Report for the Grenfell Tower Inquiry

The application for Building Regulations approval (Part B Fire) in relation to the refurbishment of Grenfell Tower - extent of control, the Building Control process adopted, the referenced guidance and practices adopted

Beryl Menzies FCABE PPBEng CBuildE CABE MRICS

October 2019 (Amended April 2020)

1:20@A1	24/09/13
SCALE	DATE
1279 (06) 110 00	
DWG. NO.	REVISION CHECKED

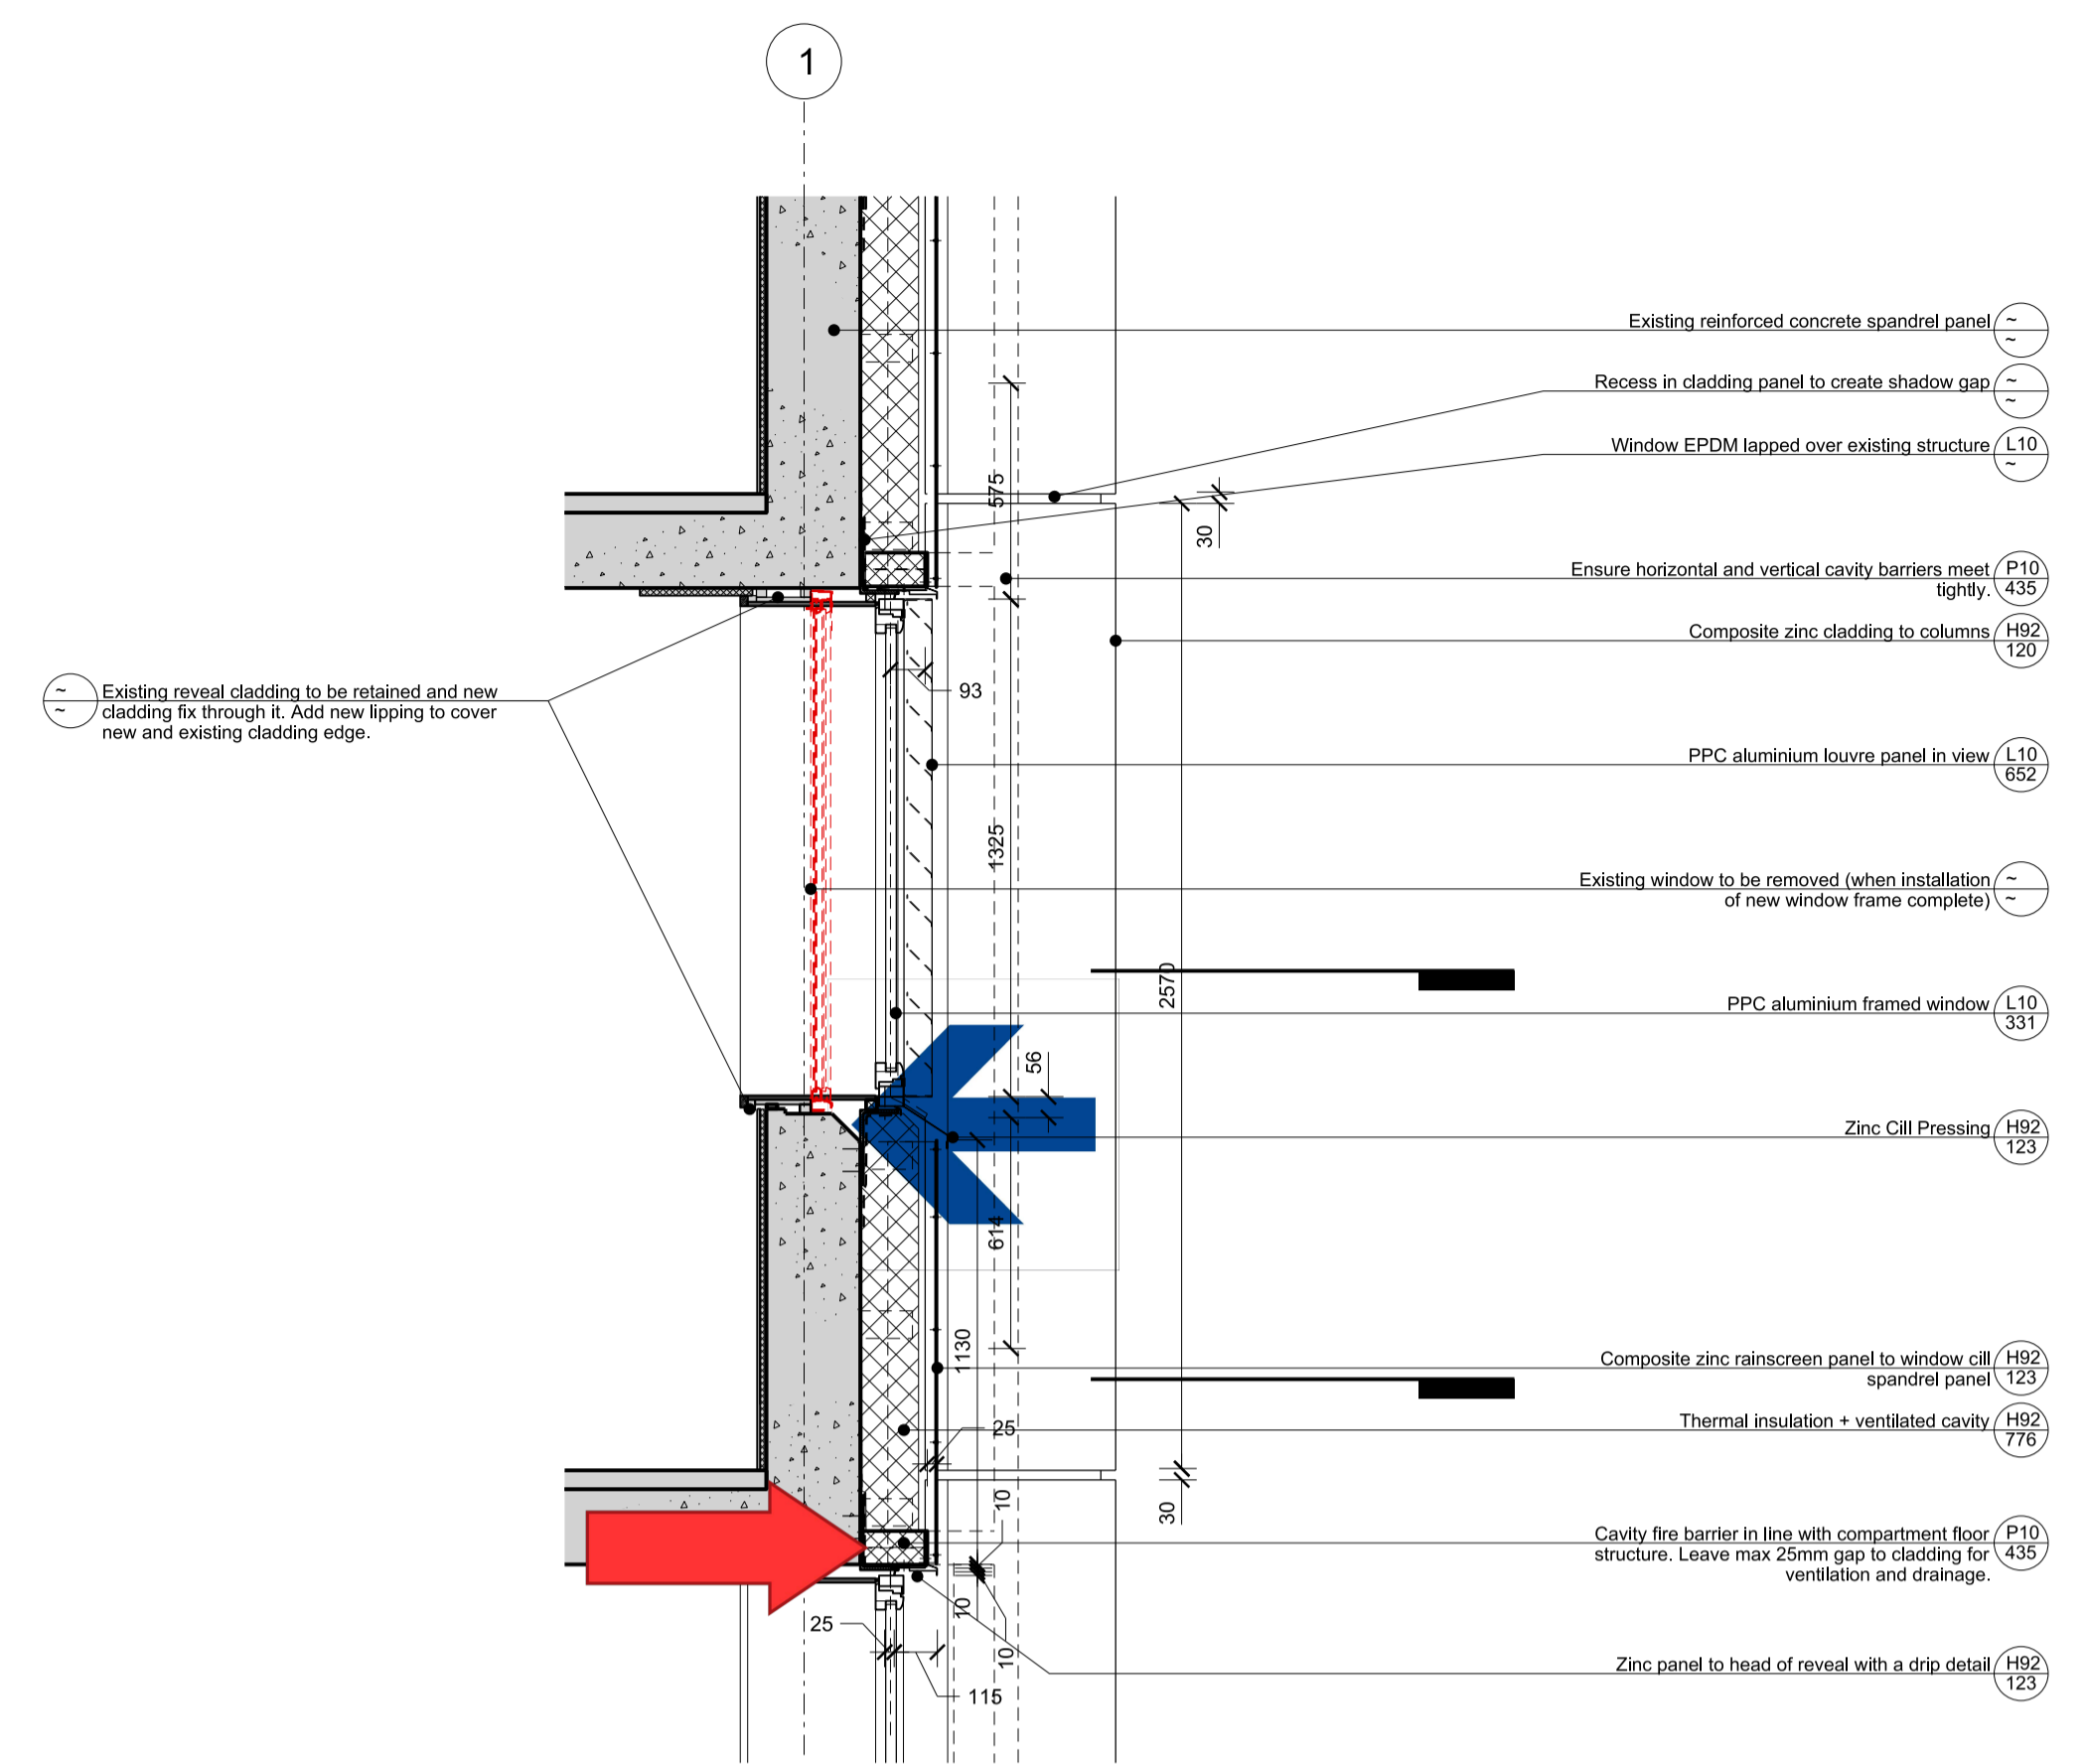
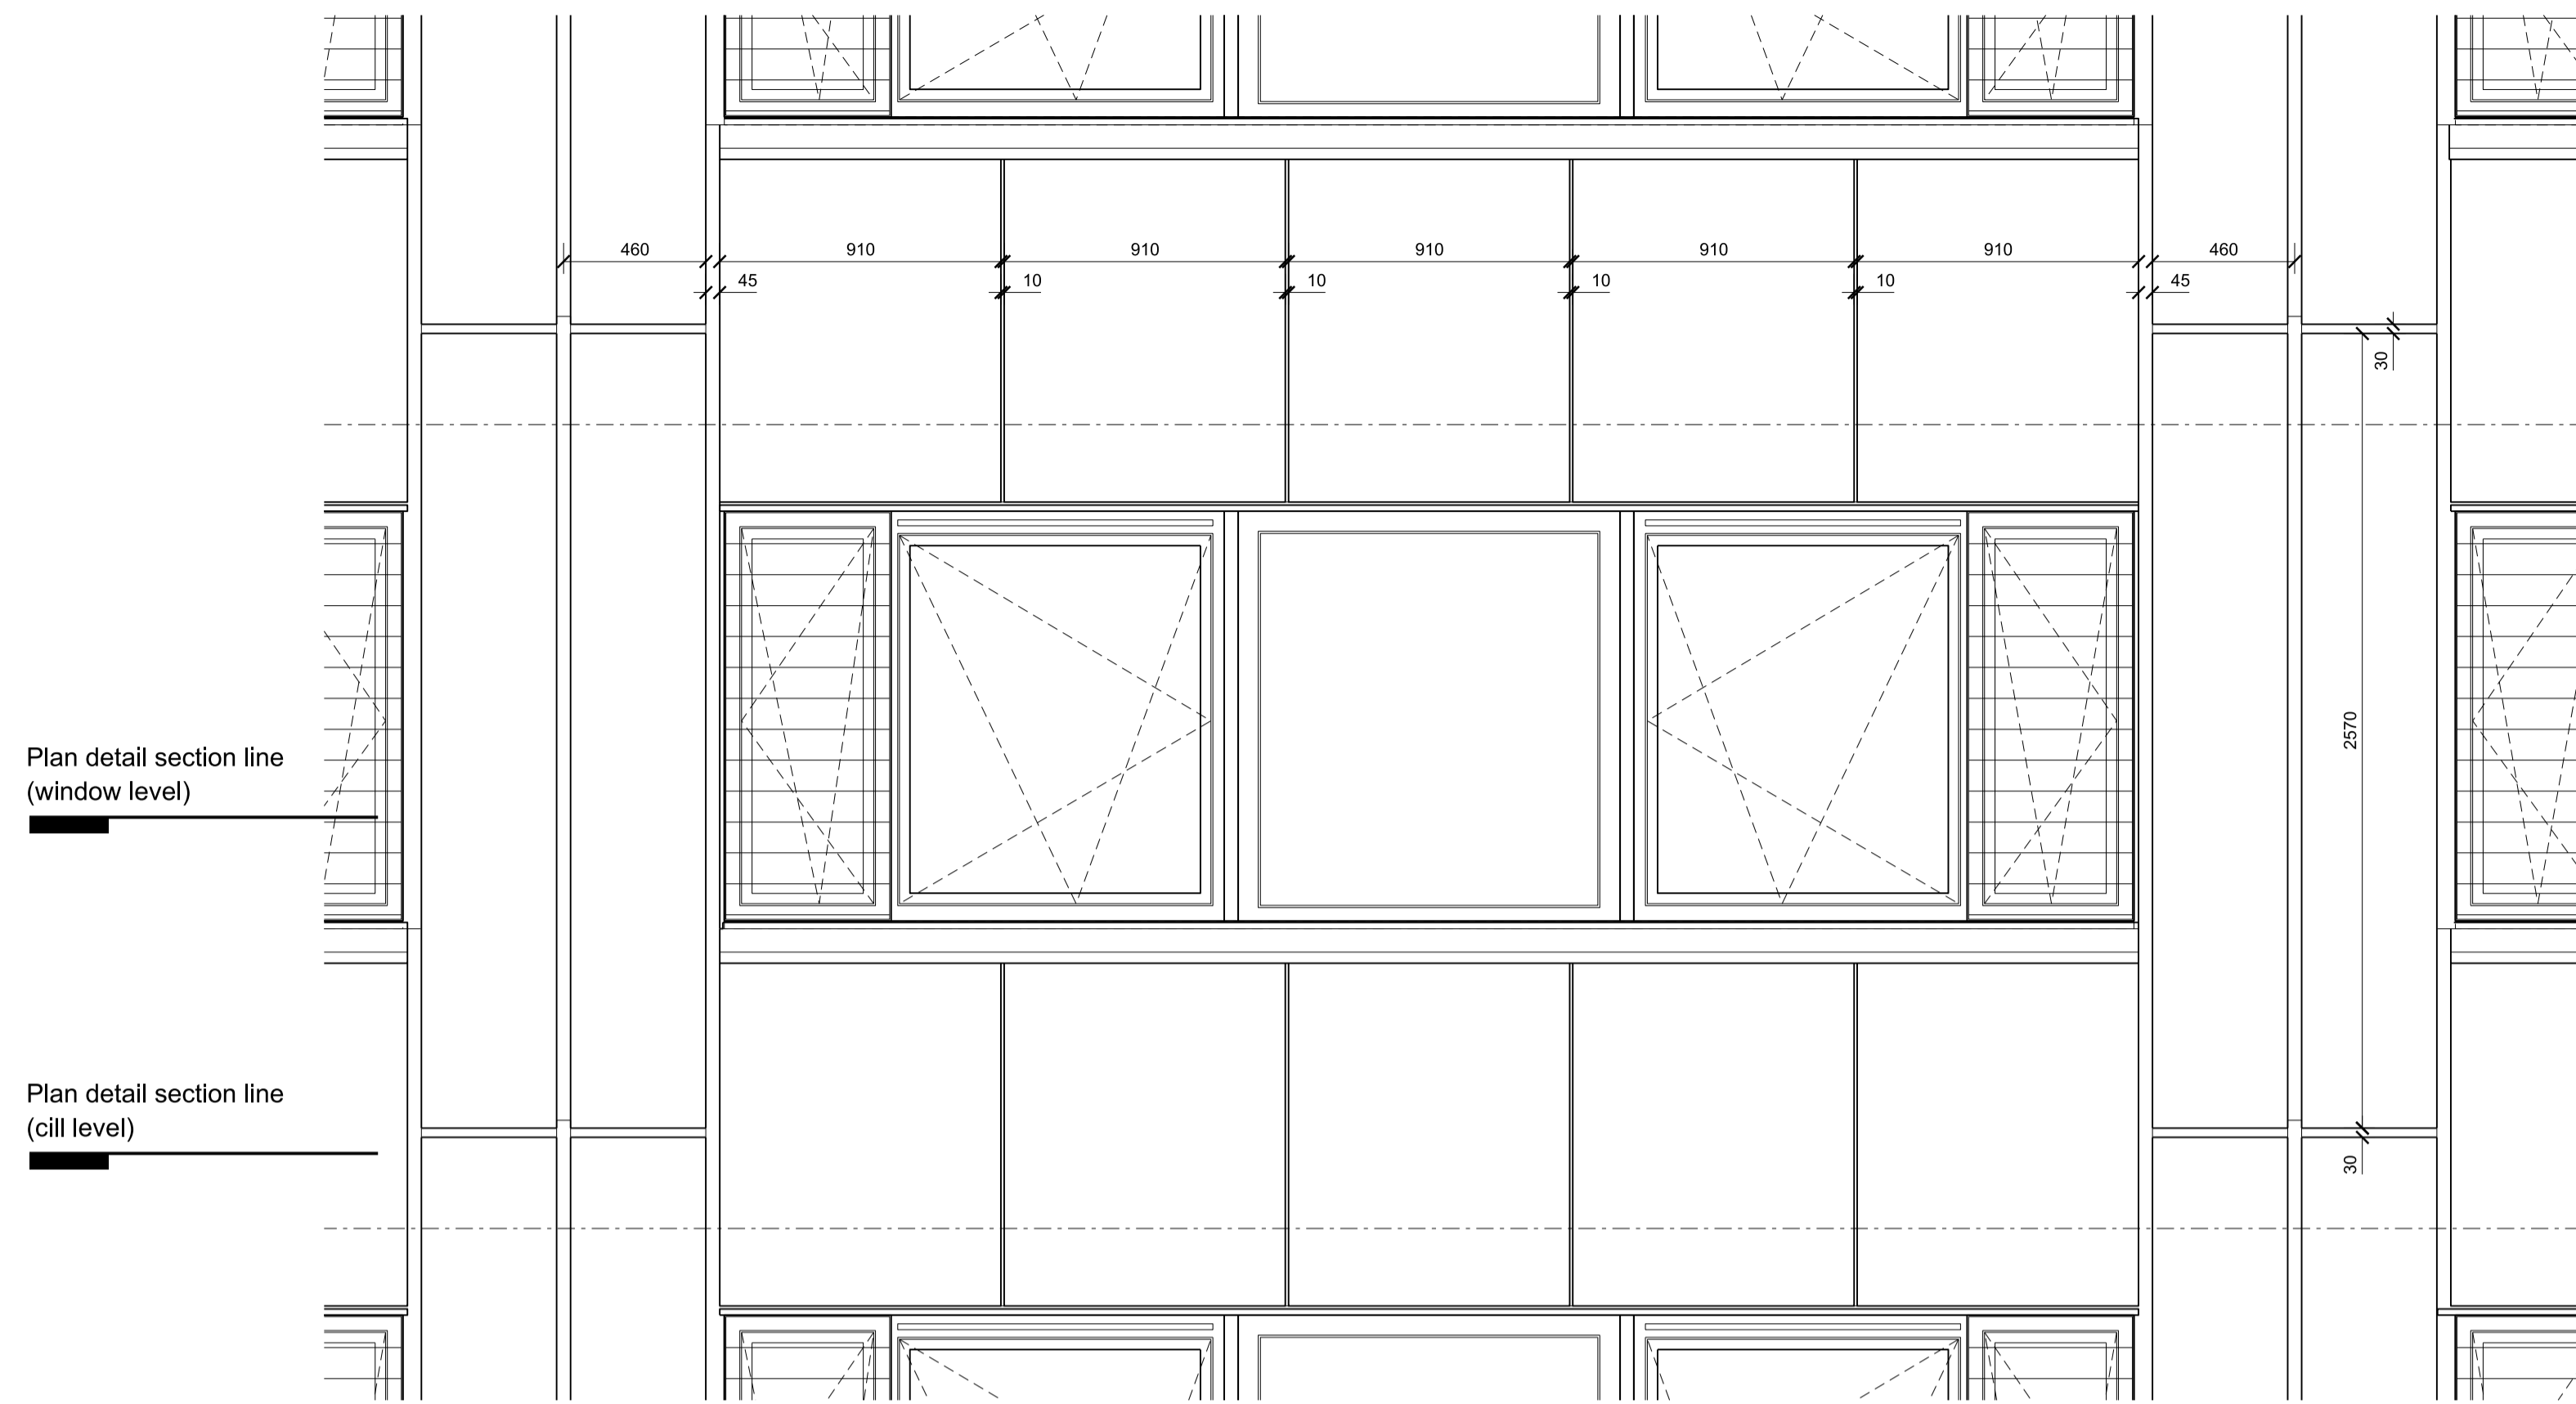
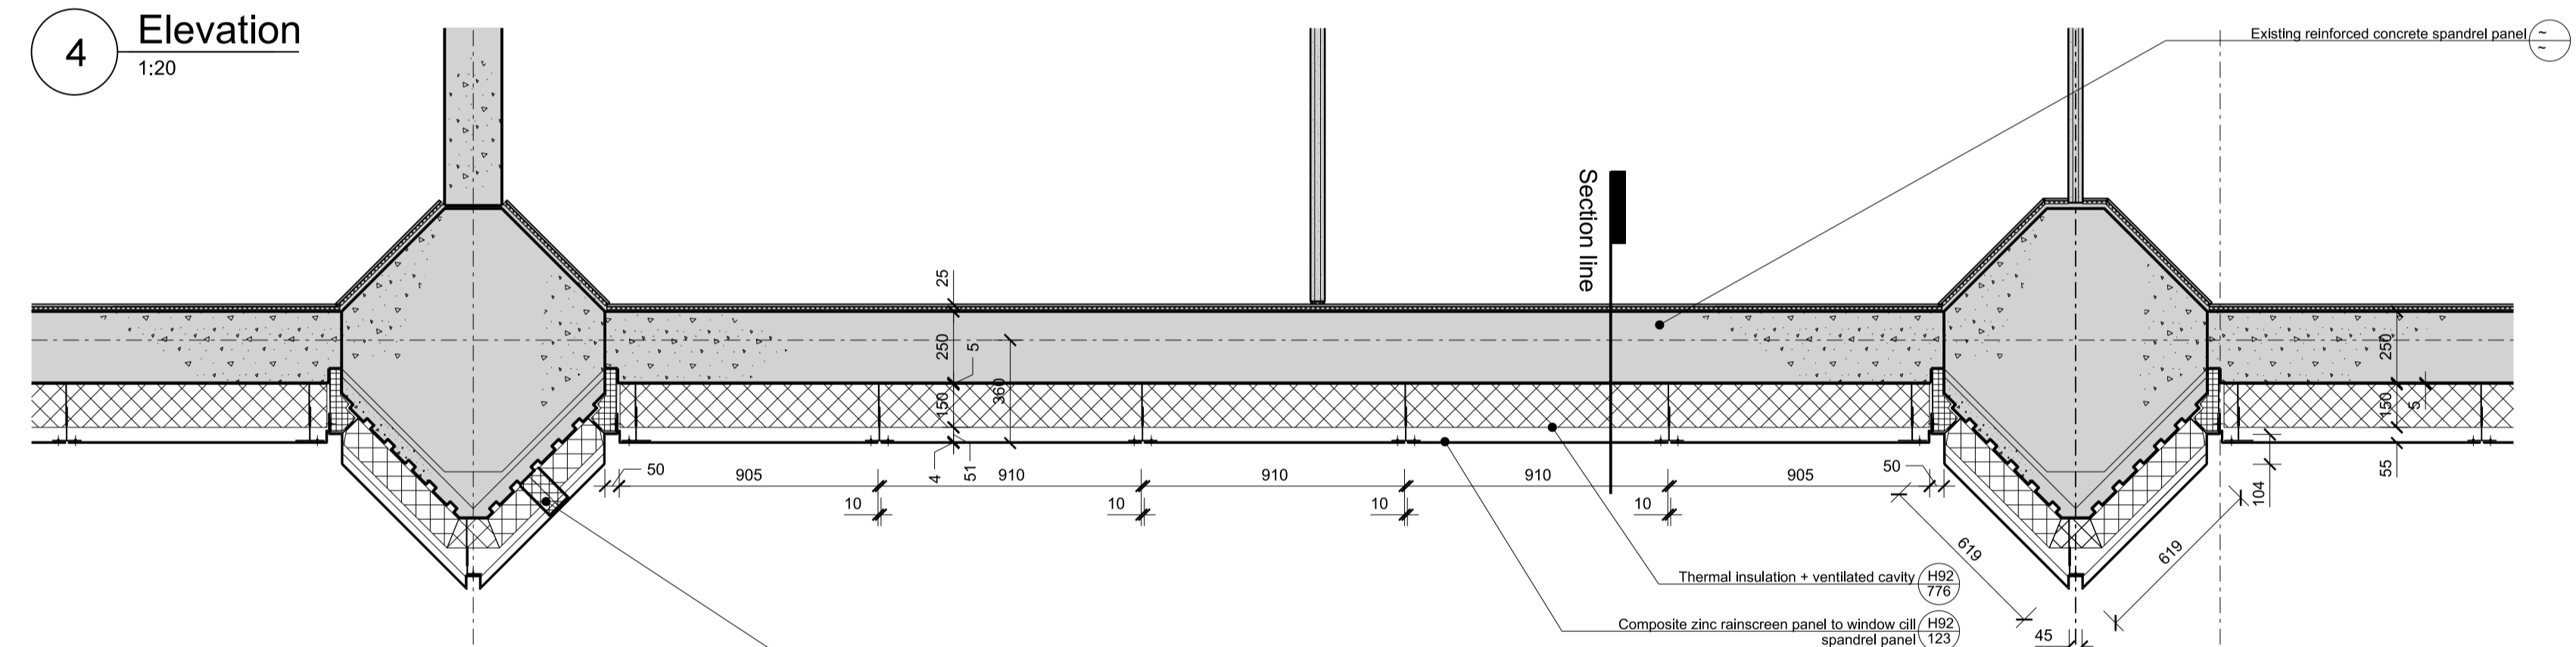
- 396) The details that were accepted by the BCB are shown in Studio E drawings 1279 (06) 110 rev 00 {HAR00006598}, 120 rev 00, 121 rev 00 {HAR00006597} and Harley’s drawing C1059-325 rev C {HAR00006599} (covering email is {HAR00006596}). These are shown below. The Inquiry will note that the Studio E drawings did not include cavity barriers at the head, jamb or bottom of the windows. In the Studio E drawing 1279 (06) 120 00, there is a cavity barrier above the head of the window in line with the compartment floor. In principle, a BCB may have considered this cavity barrier to be effective as a window cavity barrier. However, I have seen no evidence that John Hoban adopted this approach. In the Harley drawings, the cavity barriers are only shown at compartment floor lines. There is therefore an inconsistency between the drawings. I have not seen any evidence that this inconsistency was queried.

398) Drawing 1279 (06) 110 Rev 00 indicates a “Cavity fire barrier in line with compartment floor structure. Leave max 25mm gap to cladding for ventilation and drainage.”(Red arrow) This is not a cavity barrier to the window opening. The Inquiry will note that there is no cavity barrier at the base of the window above (blue arrow) where the floor is not coincident. The drawing refers to composite zinc rainscreen to window spandrel panel and is dated 24 September 2013.

-
- 399) The Inquiry will note that in drawing 1279 (06) 110 00 {HAR00019412} "Proposed plan - window level" the "existing" window position abutted the solid concrete column and the new window location is outward and abuts the new cladding and combustible EDPM giving rise to a gap through which fire and smoke could spread. A cavity barrier was required in this location (but not shown on the drawing or I understand constructed on site).
